## **HARFORD COUNTY GOVERNMENT**

### **INVITATION FOR BID NO. 14-127**

### **REPAIR & RESURFACING OF DUXBURY COURT, ETC.**

#### **Addendum No. 1**

**Parking Lots Located  
at  
212 S. Bond Street, 121 S. Main Street, Bel Air Library and Courthouse**

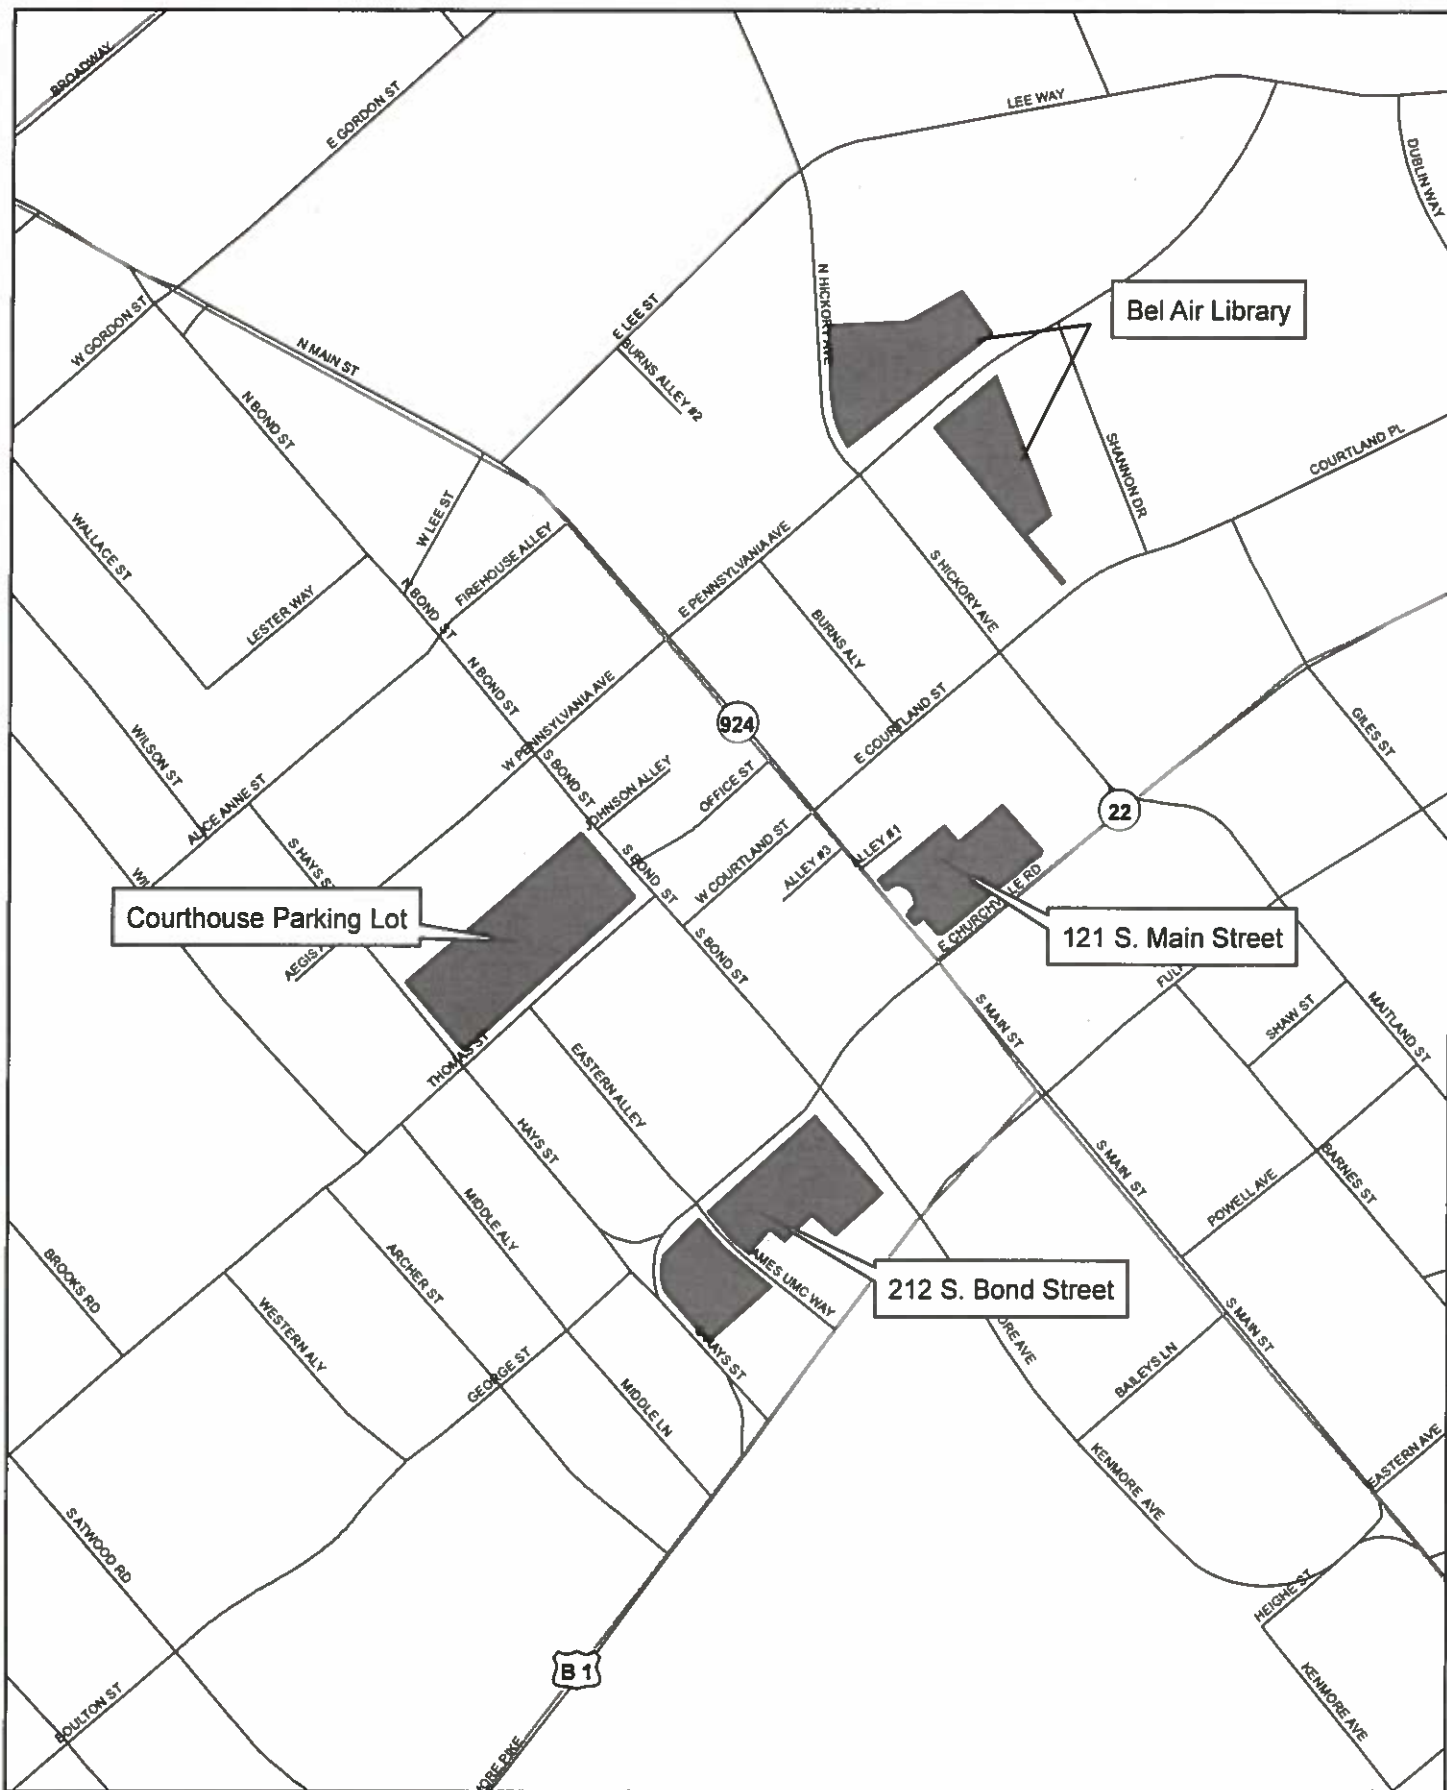
1. Remove and replace any deteriorated curb as directed by the Engineer.
2. Place 6" perforated underdrain as directed by the Engineer.
3. Remove existing paving to a depth of 1-1/2" as directed by the Engineer.
4. Cut and patch as directed by the Engineer.
5. Remove and replace concrete pad in front of Library Dumpster and at the ***entrance at 212 S. Bond Street.***
6. Place paving fabric.
7. Resurface with 1-1/2" Hot Mix Asphalt Superpave 9.5 mm PG 64-22.

7. **A contractor asked if the concrete pad at the library parking lot was included.**

*The county responded that it was.*
